**TRANSBAY TERMINAL /
CALTRAIN DOWNTOWN EXTENSION /
REDEVELOPMENT PROJECT**

**FINAL ENVIRONMENTAL IMPACT STATEMENT/
ENVIRONMENTAL IMPACT REPORT AND
SECTION 4(f) EVALUATION**

**WRITTEN PUBLIC COMMENTS AND
PUBLIC HEARING TRANSCRIPTS ON THE**

**Written Public Comments and
Public Hearing Transcripts on the
Transbay Terminal/Caltrain Downtown Extension/
Redevelopment EIS/EIR**

FIGURE 1

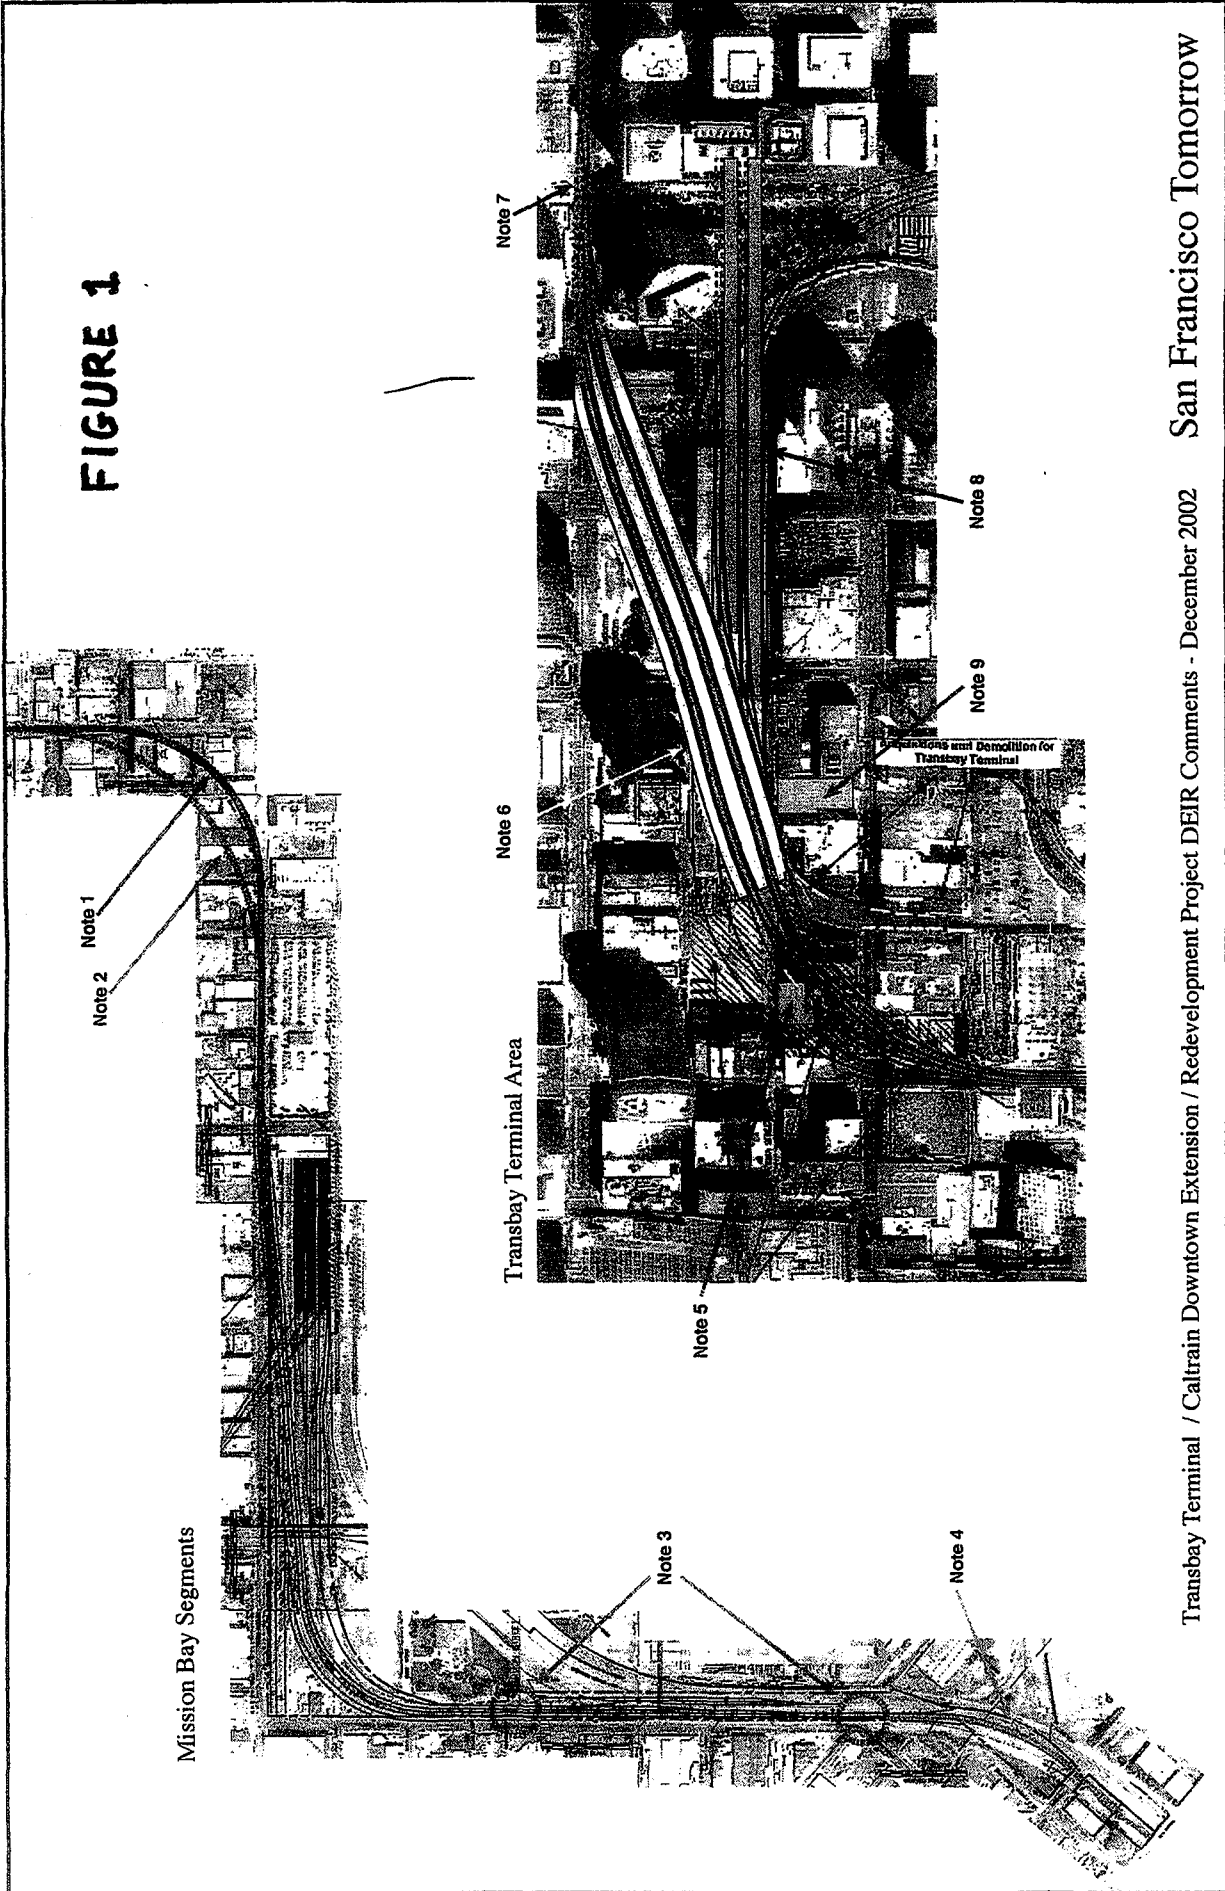
Please see the attached Figure 1 for an illustration of the recommended additional undergrounding of the Caltrain Downtown Extension and minor changes in its routing that would result in less taking of property than the alignments shown in the DEIS/DEIR.

San Francisco Tomorrow suggests an alternative platform arrangement that is similar to the 2nd to Mission alternative, but will better accommodate high speed trains (Figure 1). We find the 2nd-to-Main alternative to be seriously flawed, as the straight portion of the platforms will be only 900 feet long, too short for high speed trains. In addition, using the curved platforms in this alternative presents dangerous conditions to passengers (see Figure 2) as the distance between the platform and the train can be significant, ranging up to two feet.

As shown in the attached Figure 1, San Francisco Tomorrow advocates reviewing the track alignment at 2nd and Howard Streets for opportunities to reduce the number of historic buildings that are endangered.

Figure 1: Building Foot Print Overlaid with Caltrain Tunnel

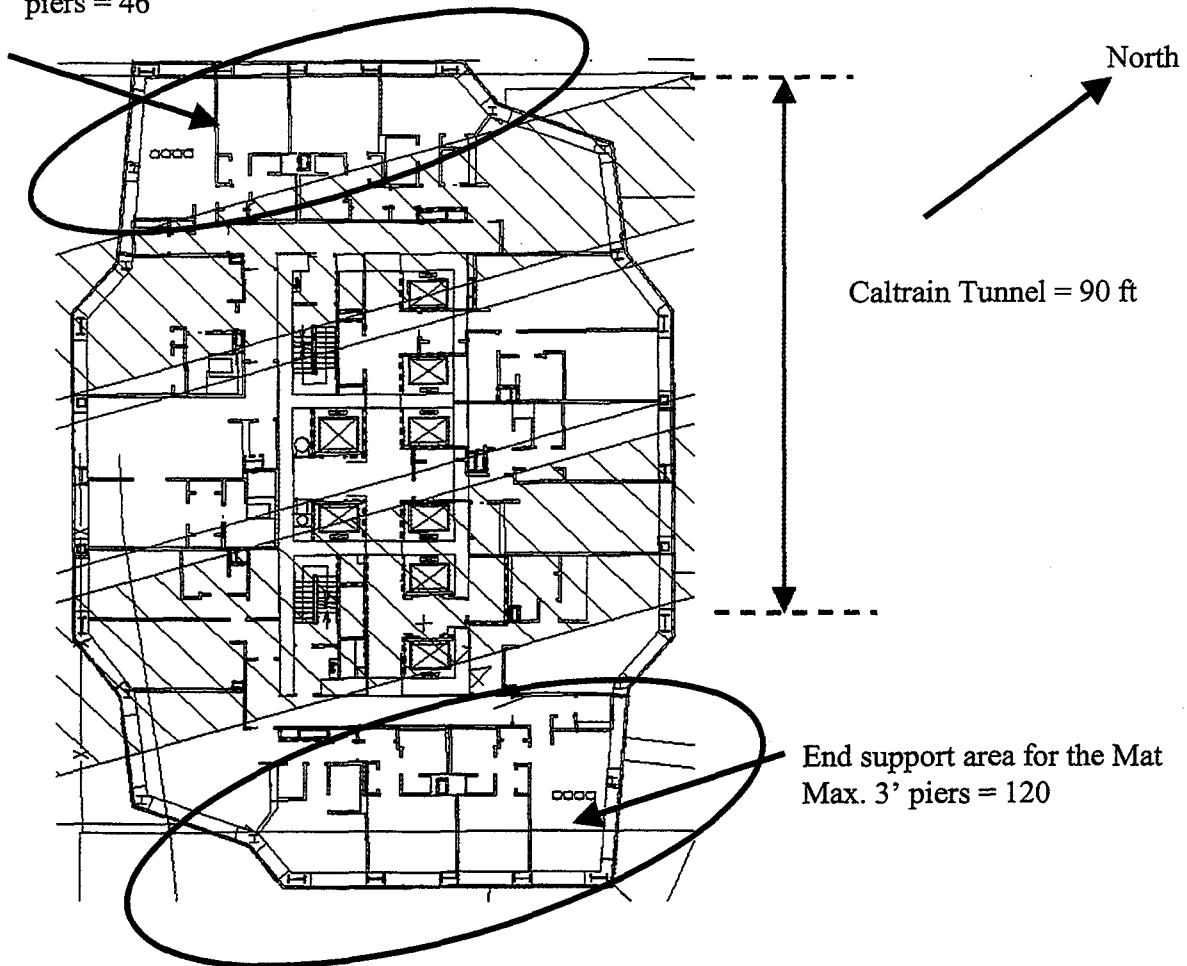
Alternate IIA would require that 301 Mission Street project provide the necessary clearances to accommodate a 90-foot wide tunnel (train track and two platforms) under the high rise structure's base. Figure 1 shows the site plan with building footprint overlaid on the proposed Caltrain tunnel.

Figure 2: Finite Element model of the Foundation Mat Slab

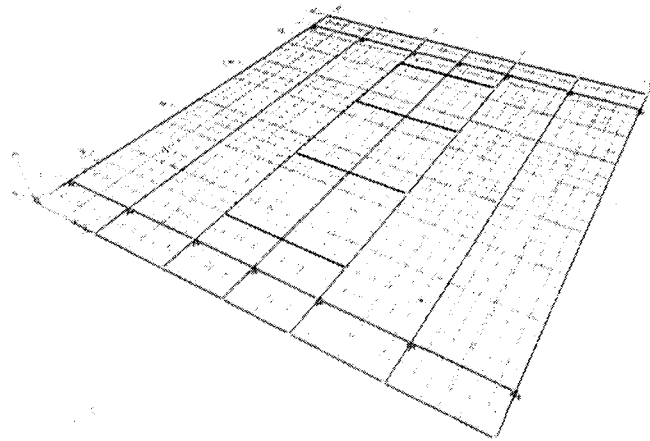
Figure 2 shows a schematic of a finite element structural model that was developed to represent a thick reinforced-concrete mat supported along its edges in one direction. The edge support conditions were approximately modeled in order to capture reasonable estimates for the reactions (e.g. tension, compression). The building core was modeled as line loads in order to capture the transfer of seismic lateral load moments from the building's superstructure to the mat. The non-seismic gravity column system was modeled by evenly distributing the building's gravity loads across the mat. Based on these estimated seismic overturning and gravity loads, the vertical deflections of the mat and internal flexural stresses were then computed.

Figure 3: Deformations for 15 ft. thick Mat

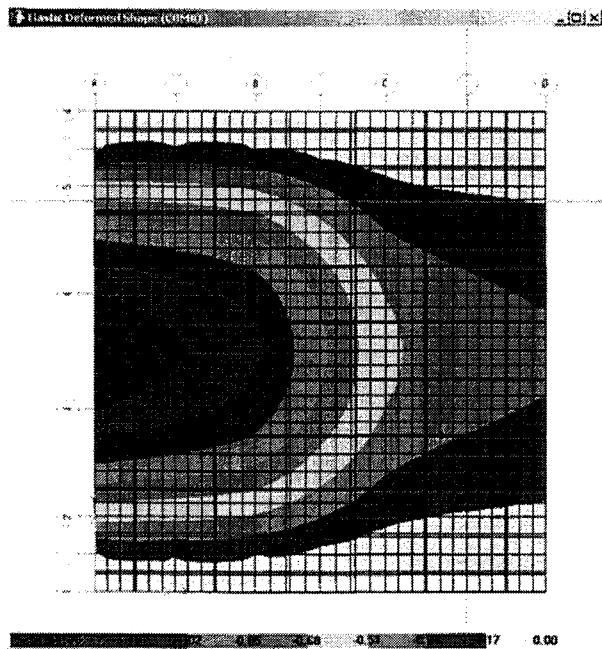
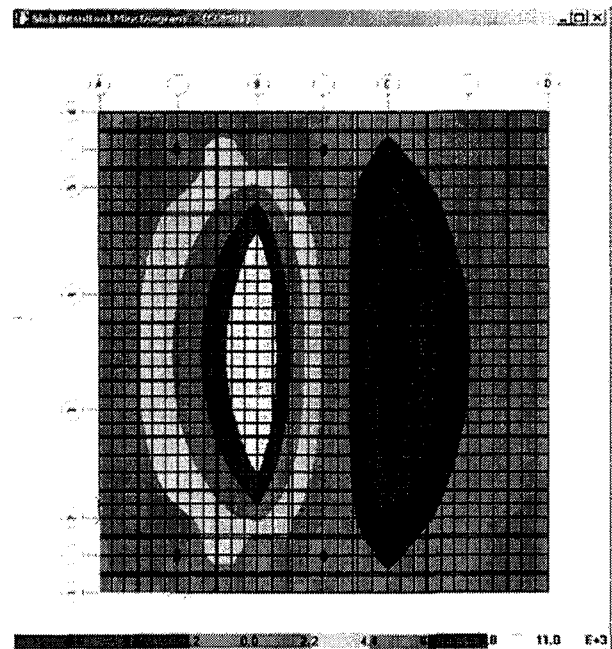
Figures 3 and 4 show deformations and flexural stresses for a proposed 15-foot thick transfer girder mat. As the mat deforms, it causes rotation at the base of the high-rise tower, which in turn results in a lateral deflection at the top of the 630-foot tall tower.

Figure 3: Foundation Plan Layout

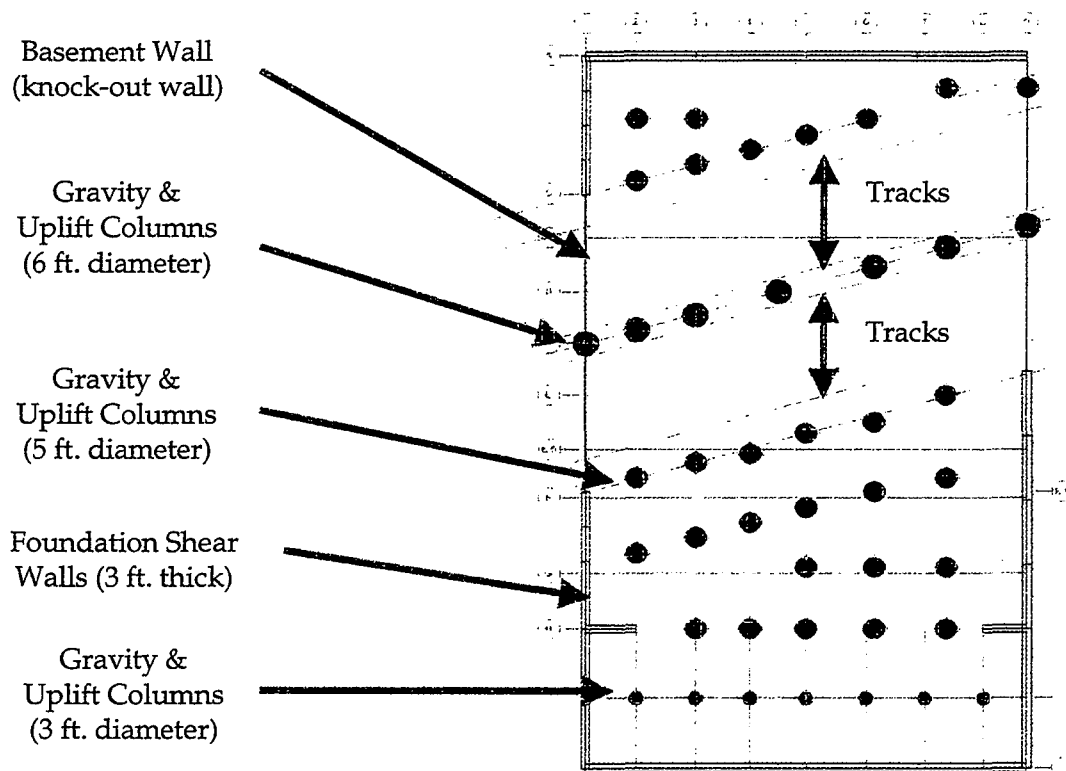
The column and shear wall layout of the below-grade structure as shown in Figure 3 does not match up with the layout of the moment frames and braced frames of the superstructure. This condition is defined as a vertical and lateral discontinuity, and according to the Code, all structural elements below such discontinuity shall be designed by multiplying the design loads by the "Omega" factor, which in this case will be 2.8. Therefore, the design forces for both the concrete mat and the foundation structure below this mat will need to be increased by 280% to conform to this Code requirement.

Figure 1

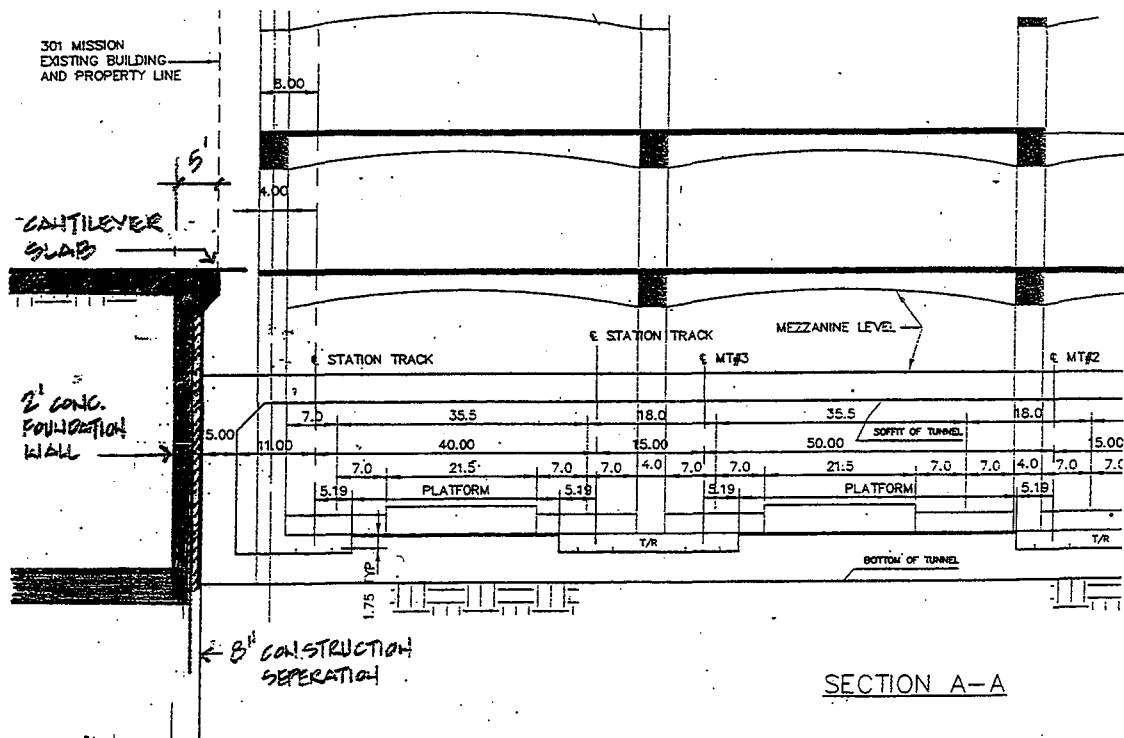
1. As indicated in drawing Section A-A the outside face of the Caltrain foundation wall is aligned 2'-0" over the property line of the project, which we have assumed as a starting point for construction purposes (see figure 1).

Figure 2

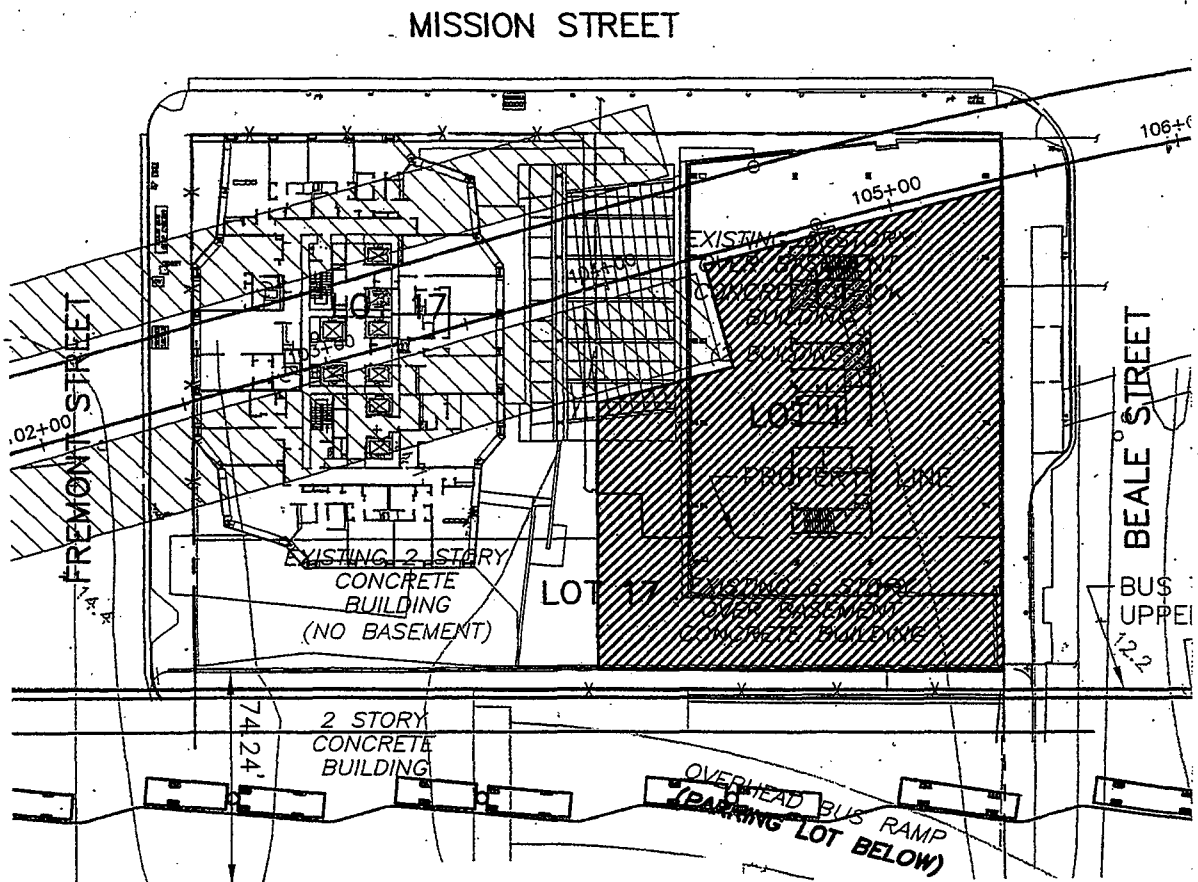
The plans indicate that the construction of a forty-five (45 ft.) deep tunnel would traverse directly through the 301 Mission Street property. The location of the tunnel and its physical configuration would significantly alter the remaining below grade buildable area on the property and would cause a redesign of various portions of the project. Judging from these drawings we have assumed that the train tunnel and the pedestrian mezzanine connecting to the bus terminals will make up approximately 2/3 of the entire site. The remaining 1/3 of the site (approximately 17,000 sq. ft.) would be free of any Caltrain construction and could be utilized for the below grade services of 301 Mission Street (see figure 2).

Figure 5

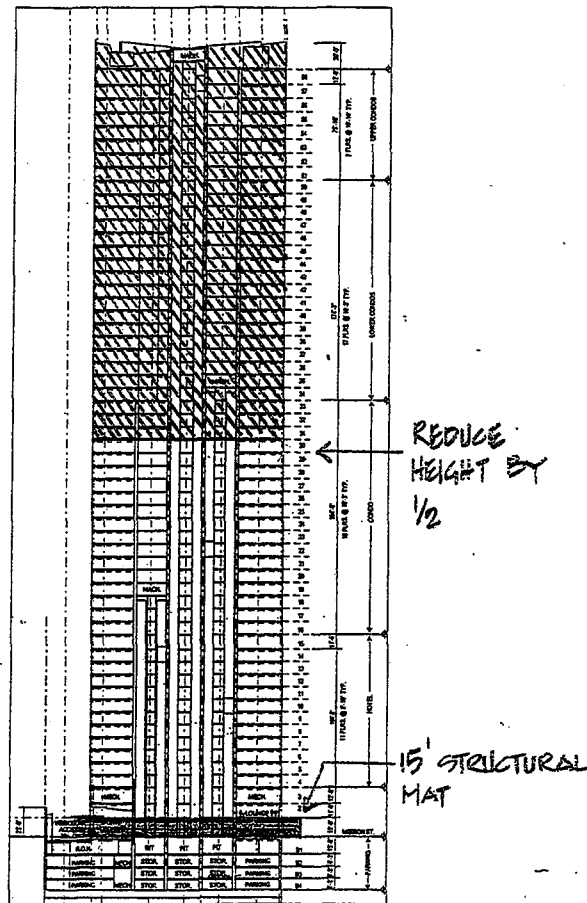
Alternative IIC is assuming that the height of the tower is reduced by $\frac{1}{2}$. According to DeSimone Consulting Engineers the thickness of the structural mat could then be reduced to 15' in thickness. The engineers have concluded that, as in Alternative IIA, the required piles cannot be accommodated on the site. Although the thickness is reduced, this alternative is substantially similar to Alternative IIA in its program and urban design impacts. Similar to alternatives IIA and IIB described above the configuration of the mat in this alternative will also interfere with ground floor functions, i.e. residential and hotel lobbies, vehicular access and loading access. In addition to the programmatic issues that this solution creates at the ground floor and below grade, reducing the tower by $\frac{1}{2}$ its height will also eliminate over 400,000 sq. ft. of program, most or all of which would be residential units, depending on the revised program mix. (See figure 5).

Figure 5

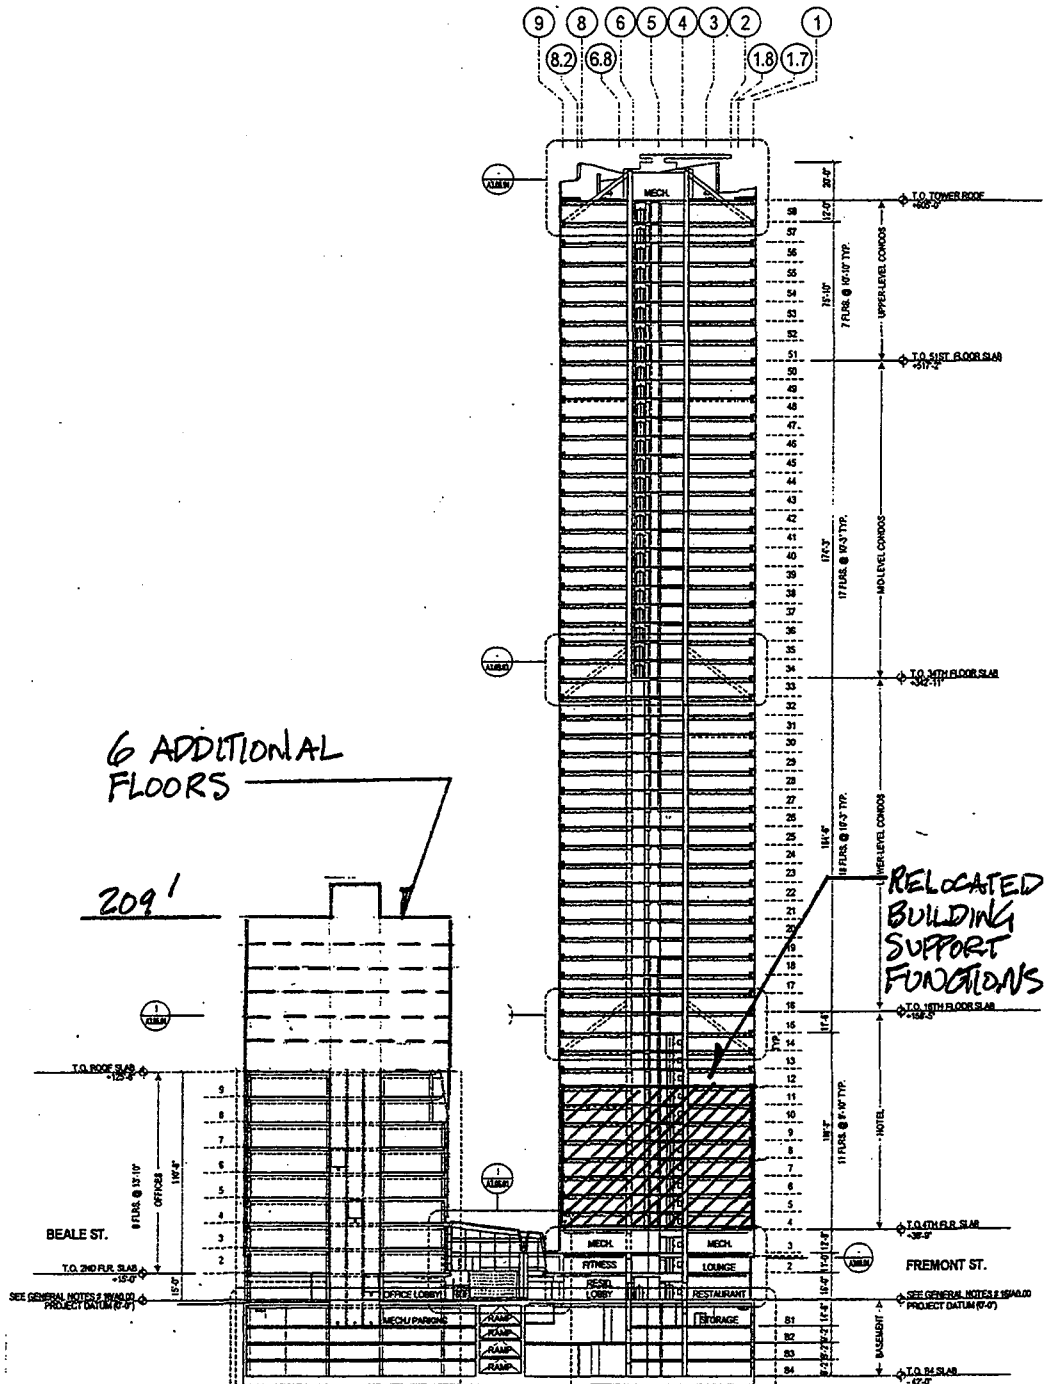
To address the displaced square footage from the residential tower, the area could be relocated to the office tower. This would increase the office tower 6 floors, from, 9 floors to 15 floors (Fig. 5), and increase the height of the office tower 83 feet, from 126 feet to 209 feet. Please note, the 84,714 represents net square feet associated with the support functions that would replace 8 floors of F.A.R. from the residential tower, totaling about 103,050 gross square feet, and equivalent to 6.3 current office floors, rounded here to 6 floors.
